# Oakdale Industrial Estate Site 1A

Proposed Section 75W Modification to MP 08\_0066

August 2012

FIGURE 1 – COMPARISON OF EXISTING AND PROPOSED MODIFICATIONS TO SITE 1A DEVELOPMENT

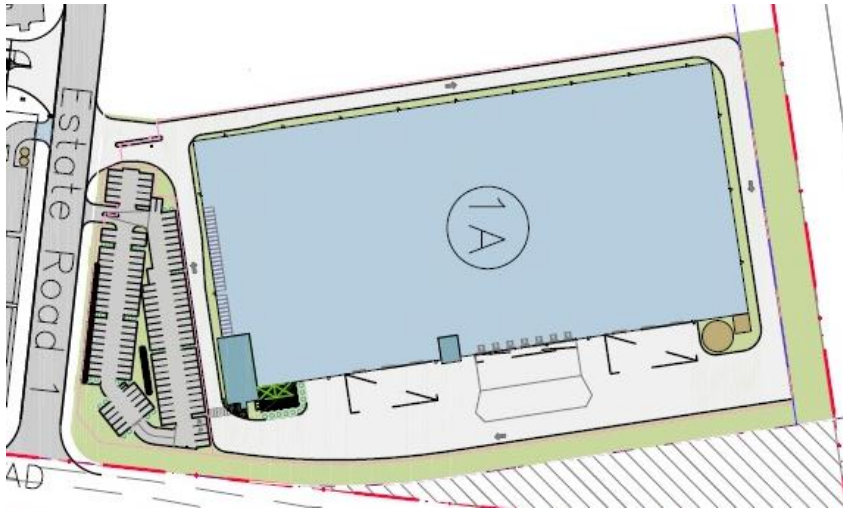
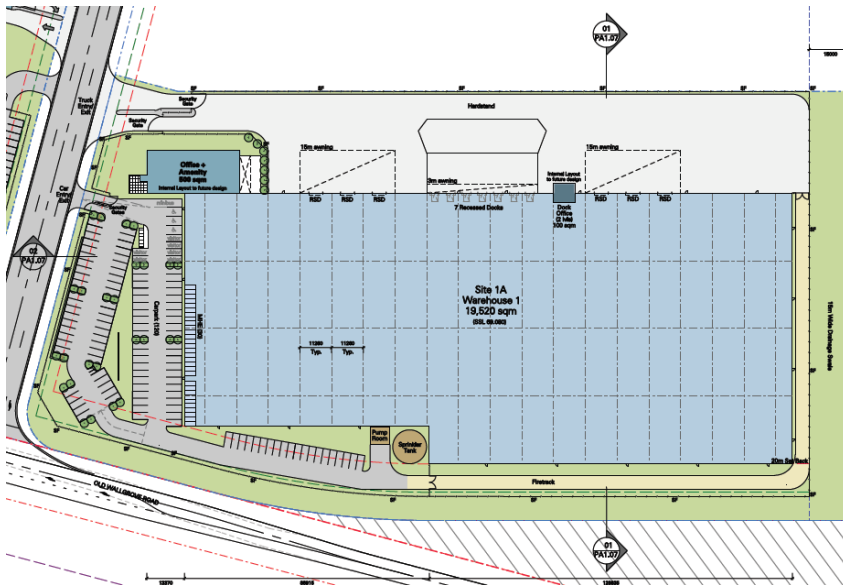
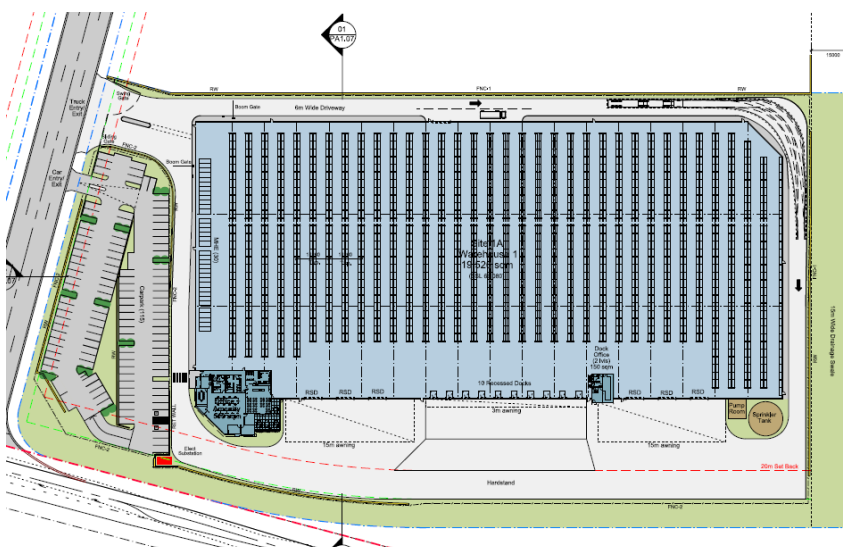
- Rotating the warehouse building envelope 180 degrees so that the hardstand is on the opposite side than that approved. Modification to the positioning and orientation of the warehouse and distribution building will include the following:

- Siting of the warehouse building moved further to the north of Site 1A.
  - Orientating the warehouse to accommodate the back of house and loading areas along the eastern elevation adjacent to Old Wallgrove Road.

- Associated relocation of the pump room and sprinkler tanks to the north east corner of the site.
  - Locating the main office in the south east corner of the building adjacent to the car park.

- Minor increase of the dock office from 100sqm to 150sqm.
- Inclusion of three additional recessed docks in the loading areas along the eastern elevation.

- Inclusion of retaining walls along the western and south eastern portion of the site.
- Inclusion of an electricity substation in the south east of the site.

- Inclusion of racking layout and fit out plans for occupant use.
- Reduction of car spaces from 120 to 115 spaces.
